ADDENDUM 2

ADDENDUM DATE: May 30th, 2025

PROJECT: United Middle School of Havelock Addition
Havelock, NC

ARCHITECT: Smith Sinnett Architecture, P.A.
4600 Lake Boone Trail, Suite 205
Raleigh, North Carolina 27607

E3-01

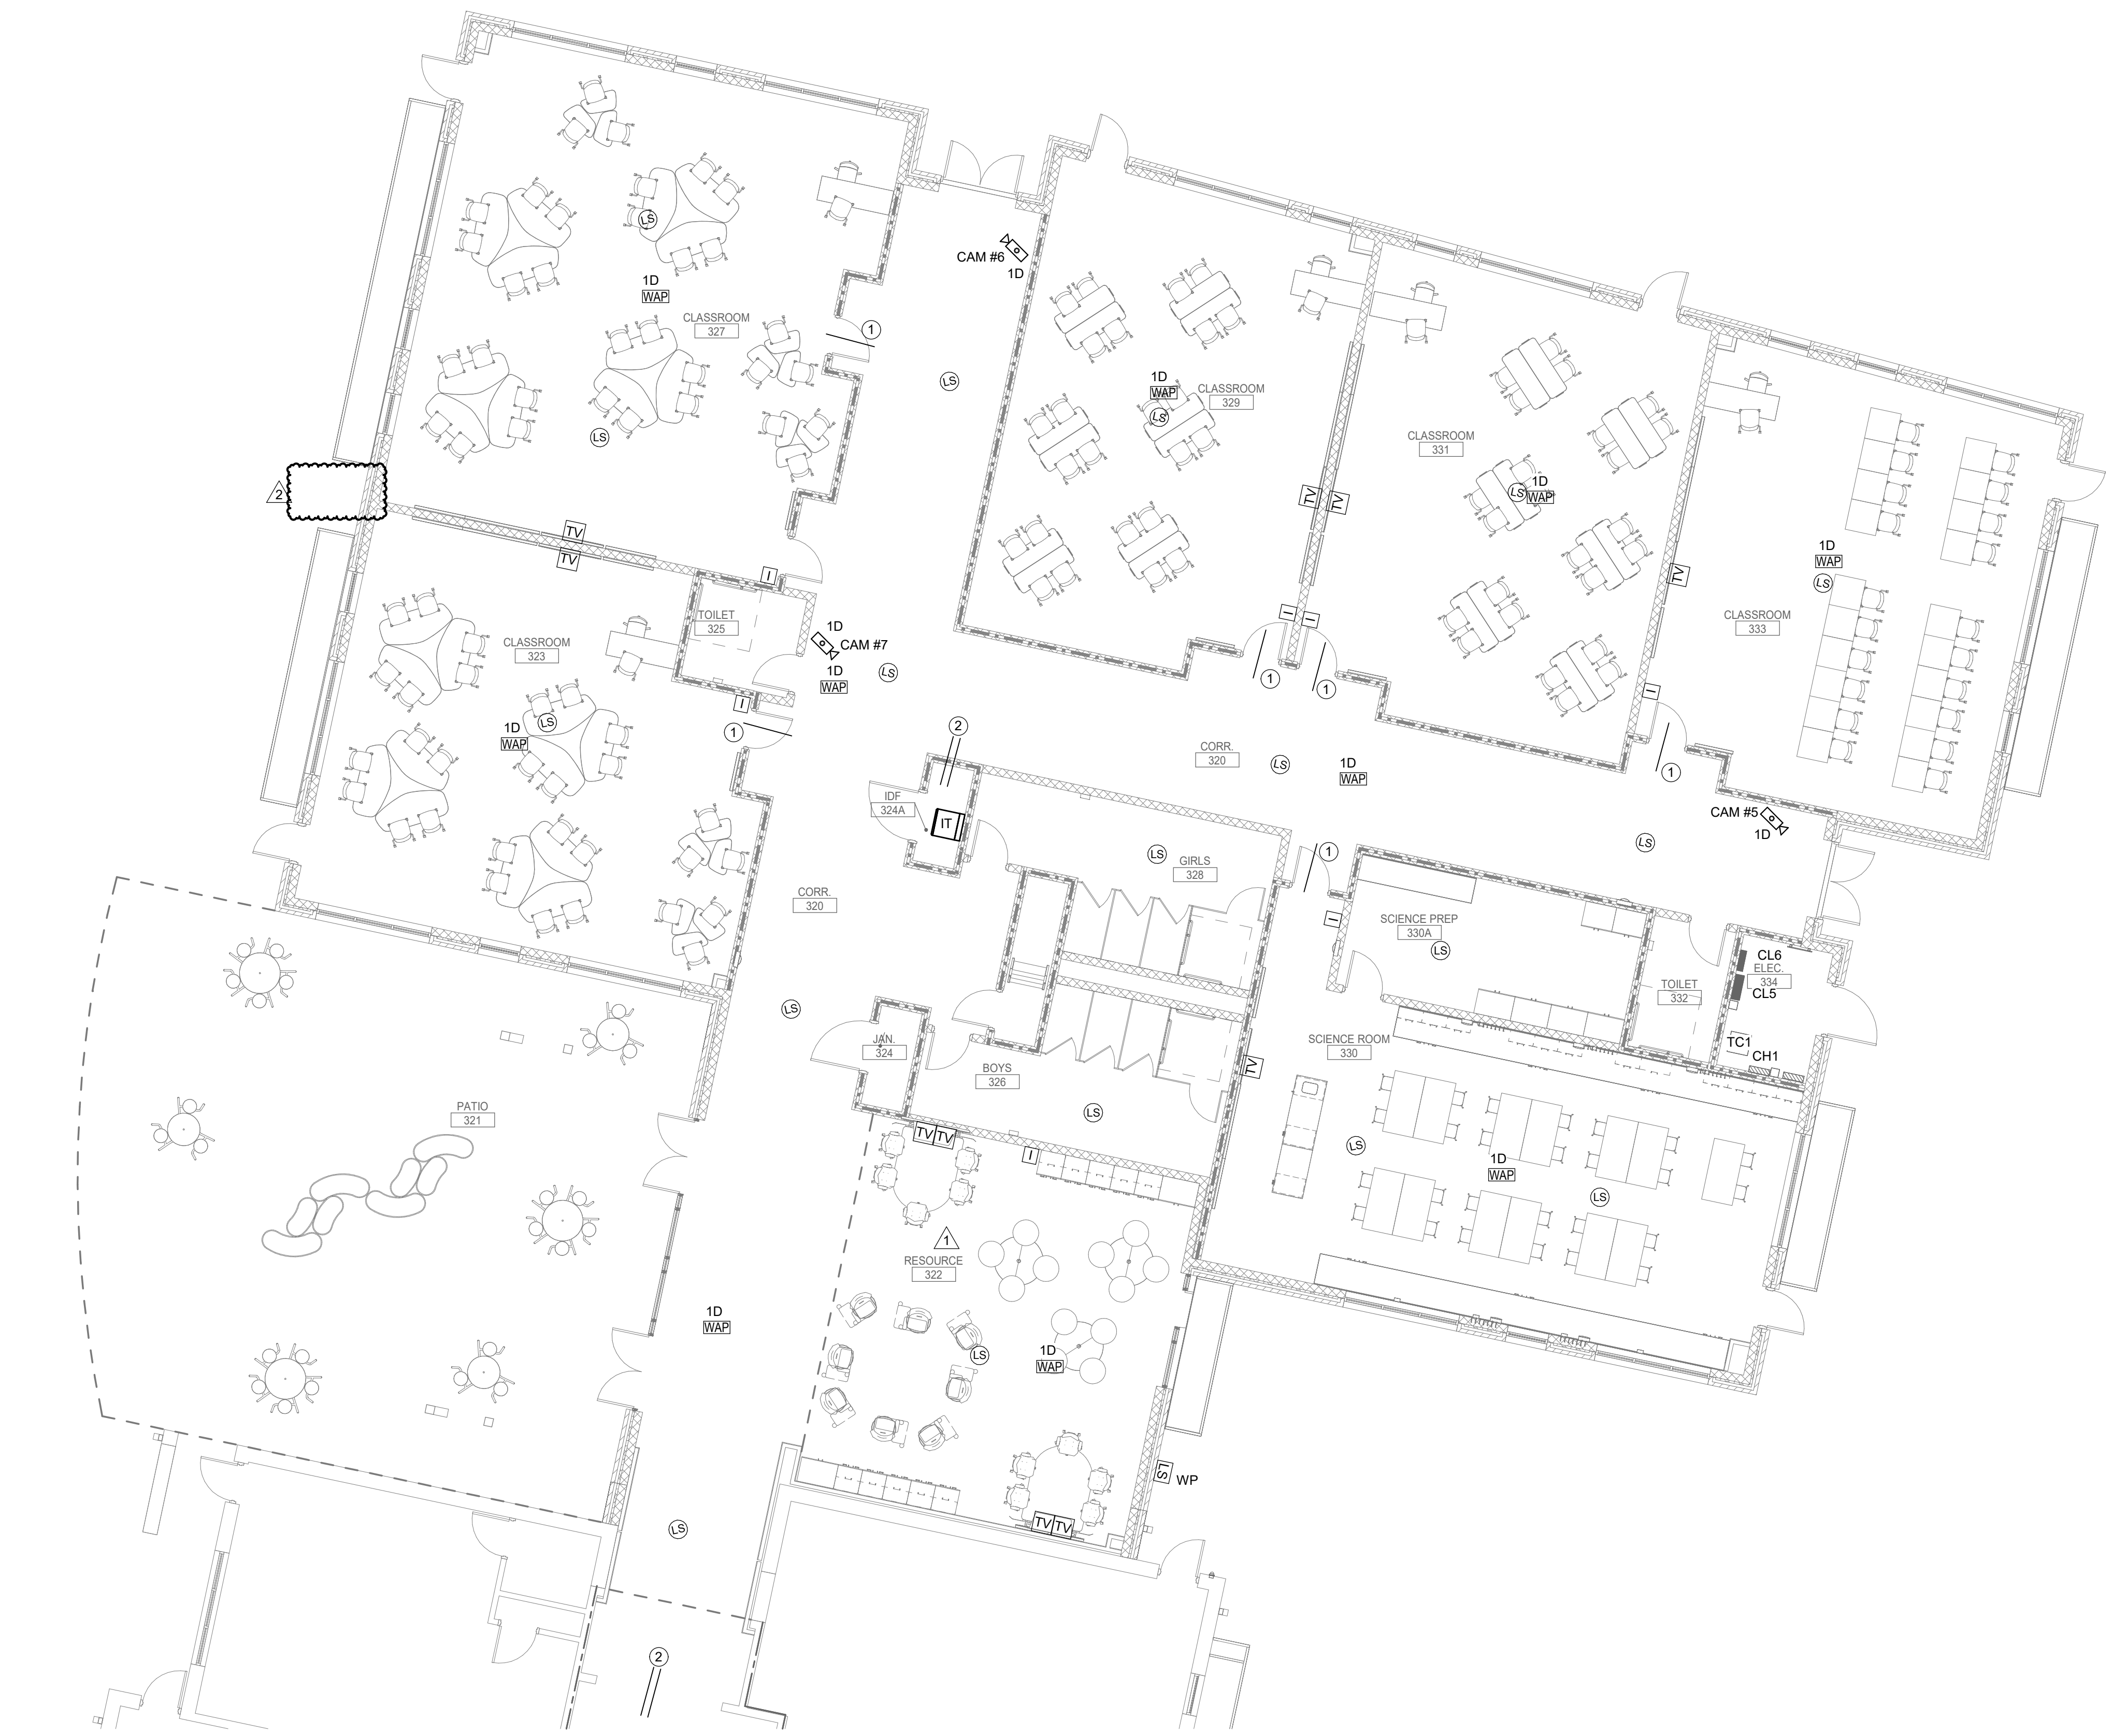
1. Drawing E0-05 – ADDED: Two smoke detector devices in Band 514 for demolition.
2. Drawing E2-06 – Removed: Wireless Access Point (WAP) symbols from drawing.
Revised: Keynote #5 to read: “Provide connection to exhaust fan. Disconnect switch provided by Division 23. Refer to mechanical equipment schedule.”
3. Drawing E3-01 - DELETED: Exterior loud speaker.
4. Drawing E3-02 - DELETED: Exterior loud speaker.
5. Drawing E3-03 - DELETED: Exterior loud speaker.
6. Drawing FA1-01 – DELETED: F/A Pull station in Book Storage 119
ADDED: F/A Pull station in Corridor 114
ADDED: F/A Pull station in Corridor 102
7. Drawing FA1-08 – DELETED: Wall mounted F/A notification devices in Band 514, Stage 516, & Chorus 519.
ADDED: Ceiling mount F/A notification devices in Band 514, Stage 516 & Chorus 519.

00 WING RENOVATION - FIRE ALARM PLAN

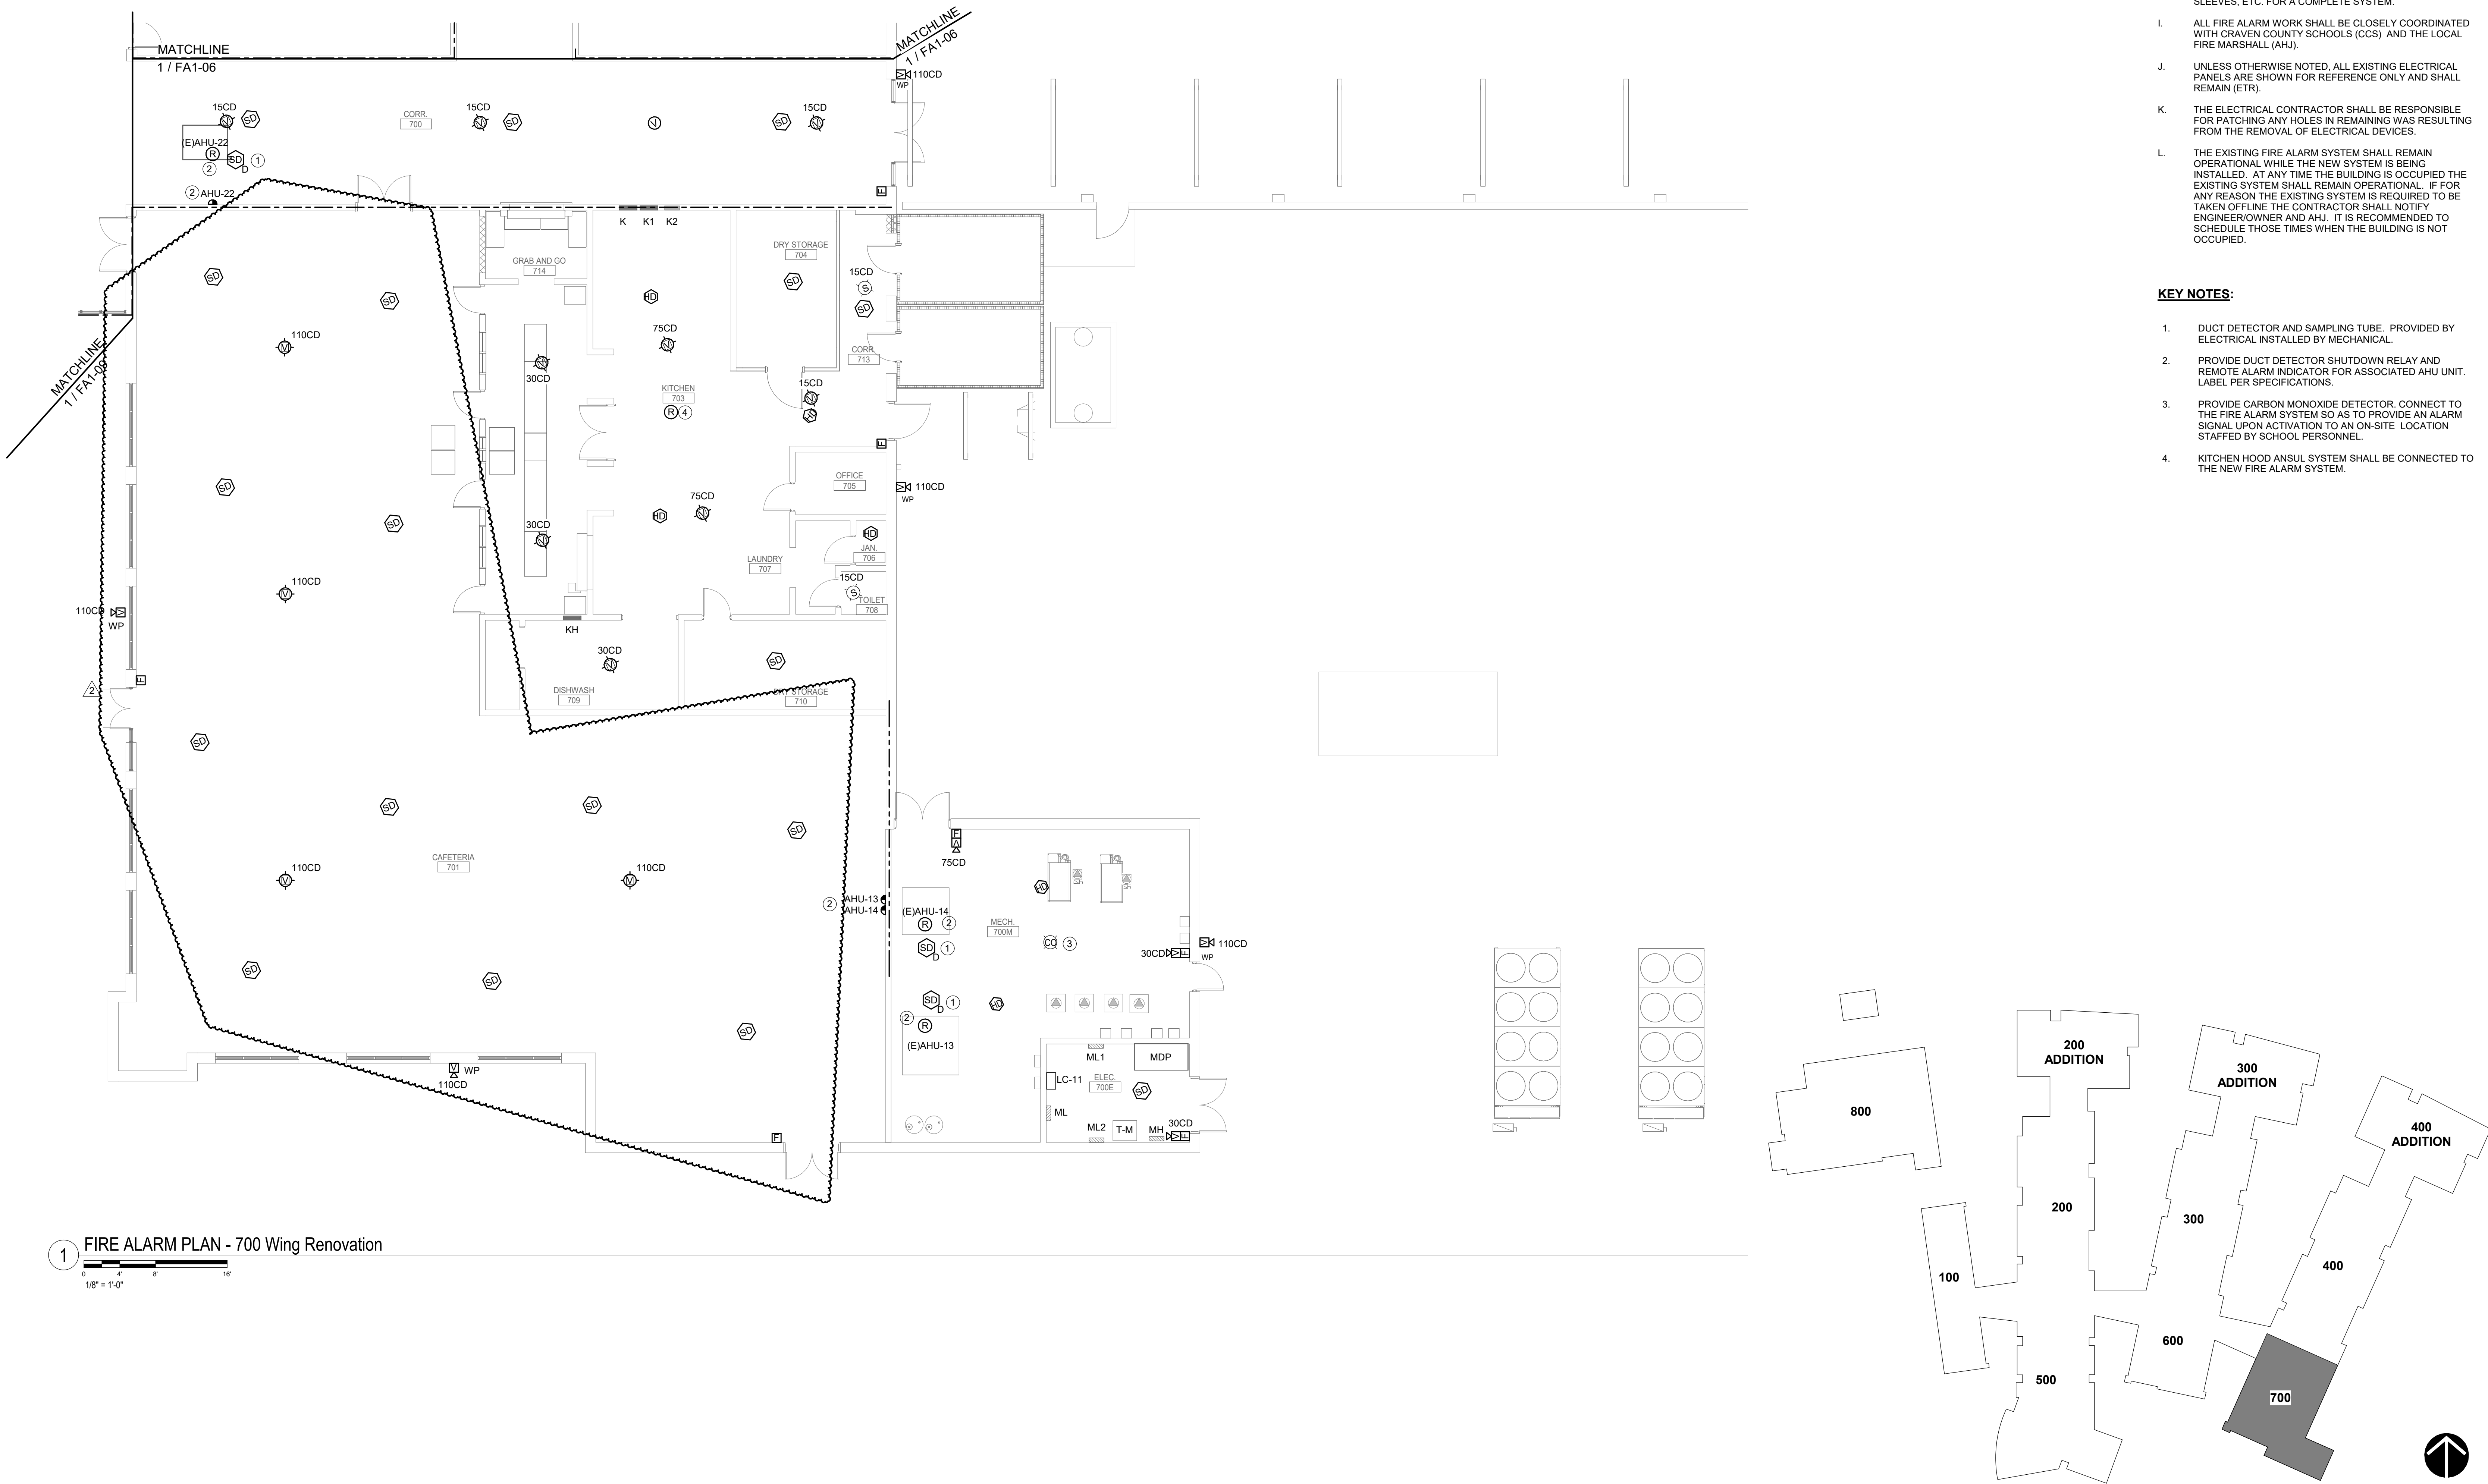
8. Drawing FA1-09 - DELETED: Wall mounted F/A notification devices in Media Center 601.
ADDED: Ceiling mount F/A notification devices in Media Center 601.
9. Drawing FA1-10 - DELETED: Wall mounted F/A notification devices in Cafeteria 701.
ADDED: Ceiling mount F/A notification devices in Cafeteria 701.
